# Background Information for the Nevada National Security Site Integrated Sampling Plan

Revision No.: 0

December 2014

### **Sampling Plan Committee Comments**

Figure B-1  
Well Categorization Flow Chart

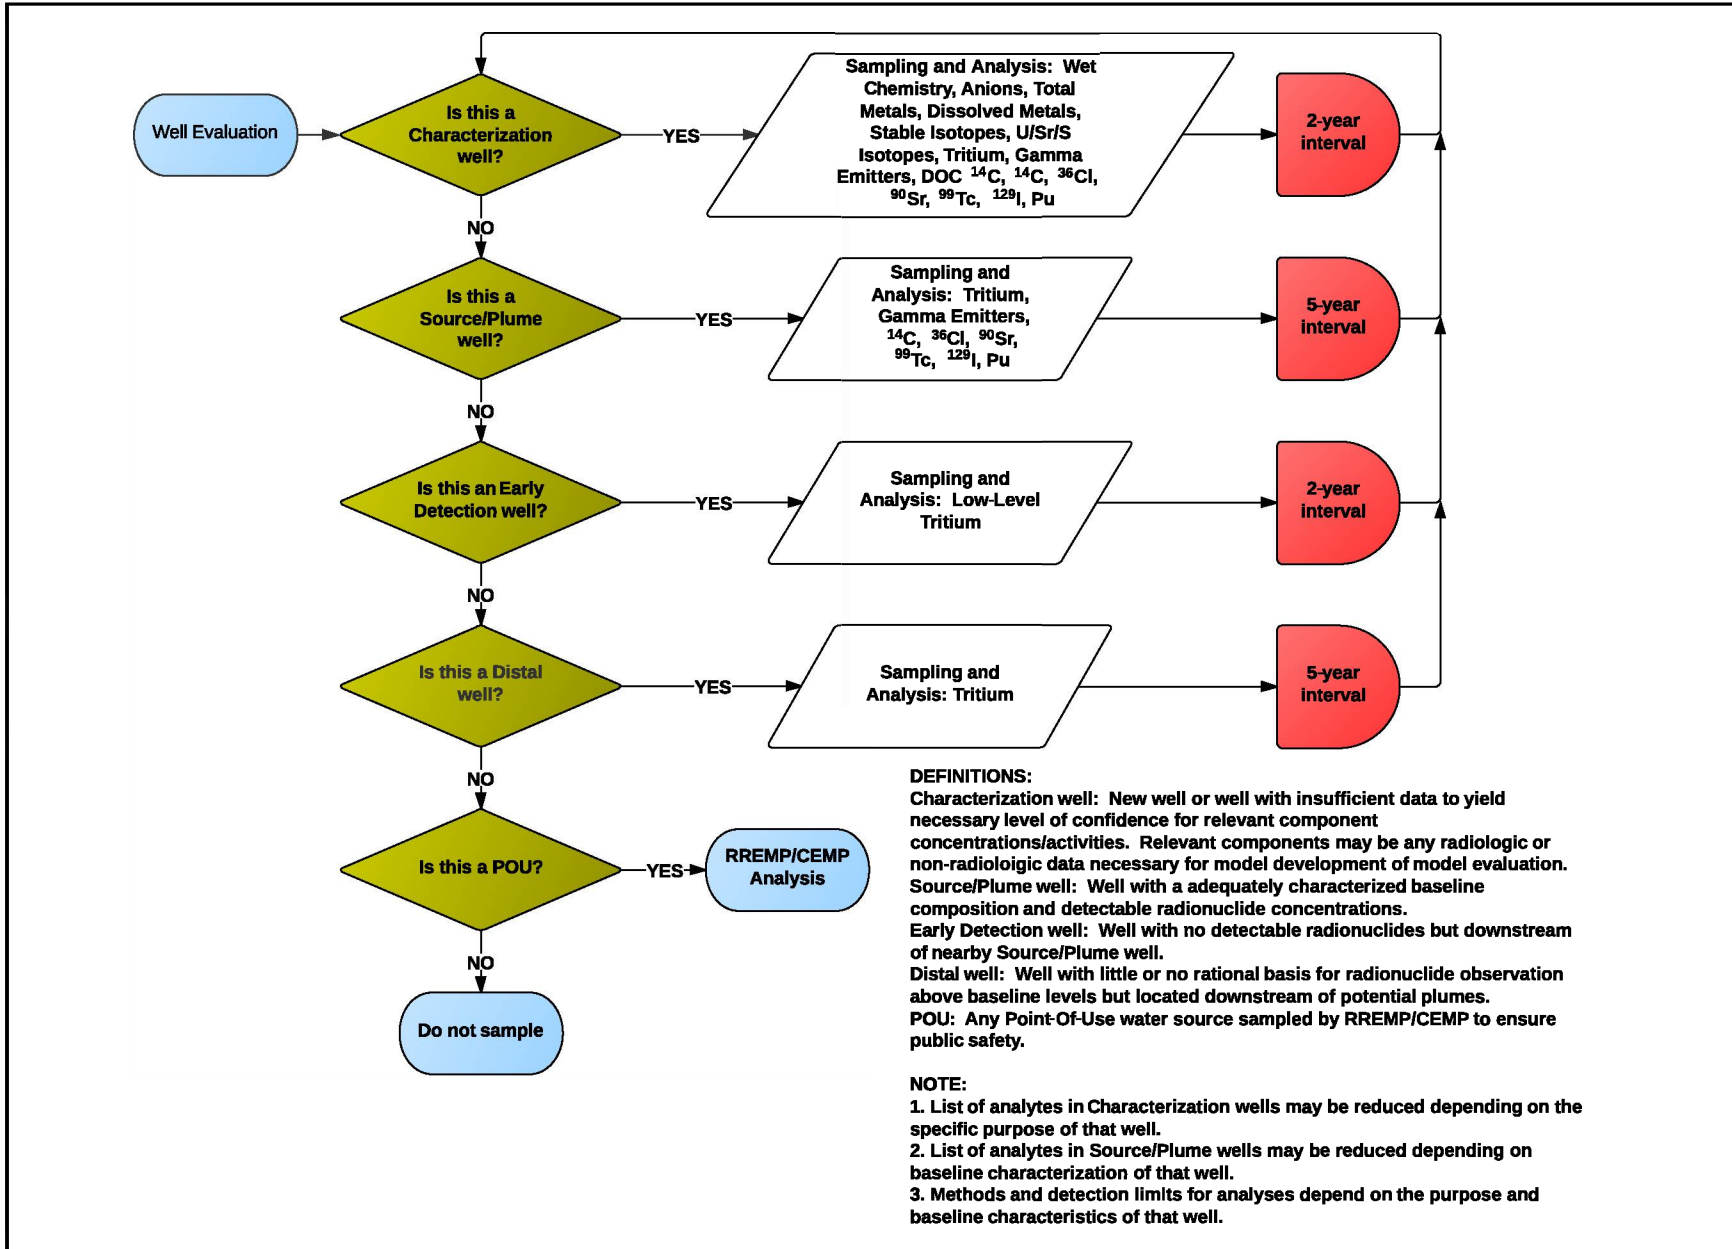
Comment	Response
<b>B.1.3 Analytes</b>	
1. Should agree on the default analyte list (by well type, and across CAUs or CAU-specific, if reasonable), but not prohibit other analytes in any group. Are we restricting to the Bowen inventory (makes sense)? That is, we're not interested in Ra-226, Ra-228, which are SDWA analytes?	The analytes are restricted to the COC based on the Bowen Inventory (Bowen et al., 2001) and not the SDWA (CFR, 2004). The default list will be defined by well type across all CAUs. This is reflected in the newly developed flowchart (Figure B-1).

**Figure B-2**  
 **$^3\text{H}$  versus  $^3\text{He}$  and  $^3\text{H}$  versus  $^{85}\text{Kr}$  for Groundwater Samples  
Collected from NNSS Wells**

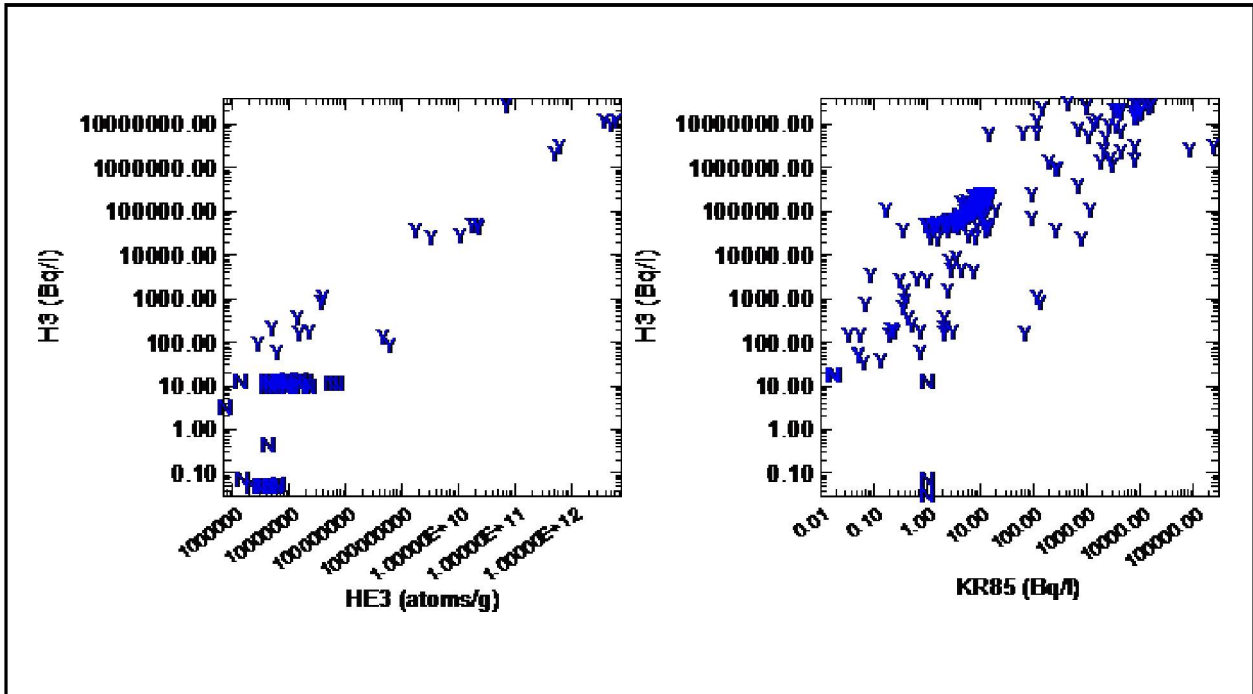
3. Not sure that you actually need to measure $^3\text{He}/^4\text{He}$ .	$^3\text{He}/^4\text{He}$ is difficult to analyze but it provides a mobile constituent that can be used to detect contaminant transport even after tritium has decayed away. The plot below is a scatter plot of $^3\text{H}$ versus $^3\text{He}$ from groundwater samples collected from wells on the NNSS (I also provided $^3\text{H}$ and $^{85}\text{Kr}$ ). Data were obtained from the UGTA Geochemistry Database. (Figure B-2). Tritium will decay away but its former presence will be discernible from the presence of elevated levels of $^3\text{He}$ . Given that monitoring will occur for 100 years, we need to develop viable surrogates for assessing the extent of contaminant transport—not for the purpose of determining whether the MCL has been exceeded, but rather for determining whether our conceptualization of transport is consistent with observations, even after $^3\text{H}$ has decayed away.
